A/YL-PS/793

補充說明

TEMPORARY DRAINAGE PROPOSAL (FINAL)

Response to Comments on Temporary Drainage Proposal (Issue 1)

Appendix C - Proposed Drainage Plan

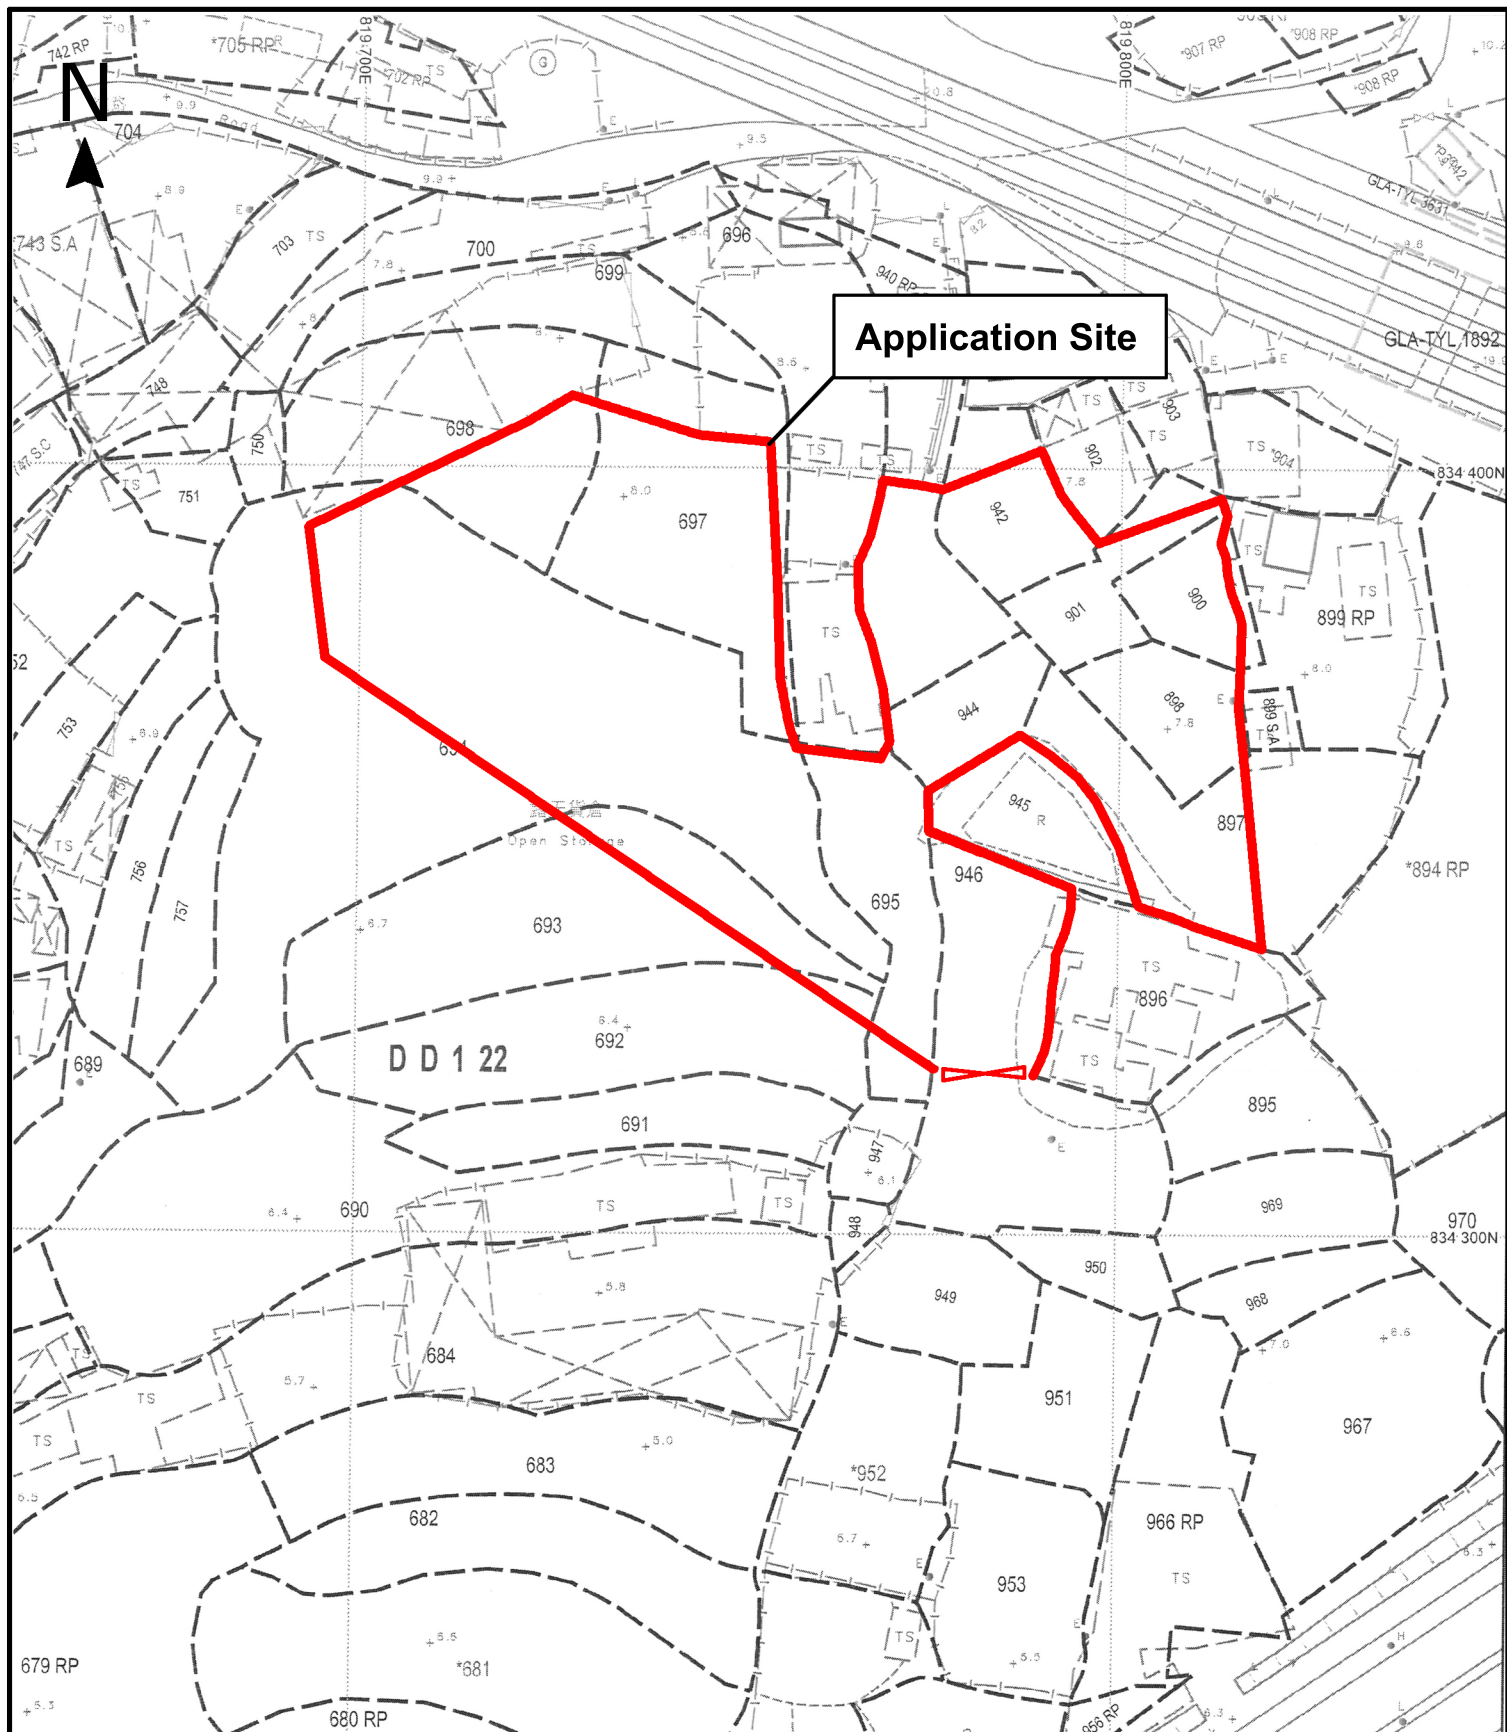
2.	Further to (ii) above, since there is no record of the said discharge path, please provide site photos to demonstrate its presence and existing condition.	Noted and provided. The site photo showing the existing discharge point is shown in Appendix C.

3.	The gradients and the sizes of the proposed U-channels should be shown on the drainage plan	The gradients and the sizes of the proposed U-channels is shown in Appendix C.

4.	Consideration should be given to provide grating for the surface channel	Noted and the grating were provided for the surface channel. Please refer to the Appendix C.

5.	The cover levels and invert levels of the proposed u-channels, catchpits/sand traps should be shown on the drainage plan.	Noted and provided. Please refer to the Appendix C.

6.	Cross sections showing the existing and proposed ground levels of the captioned site with respect to the adjacent areas should be given.	Noted and provided. Please refer to the Appendix C.
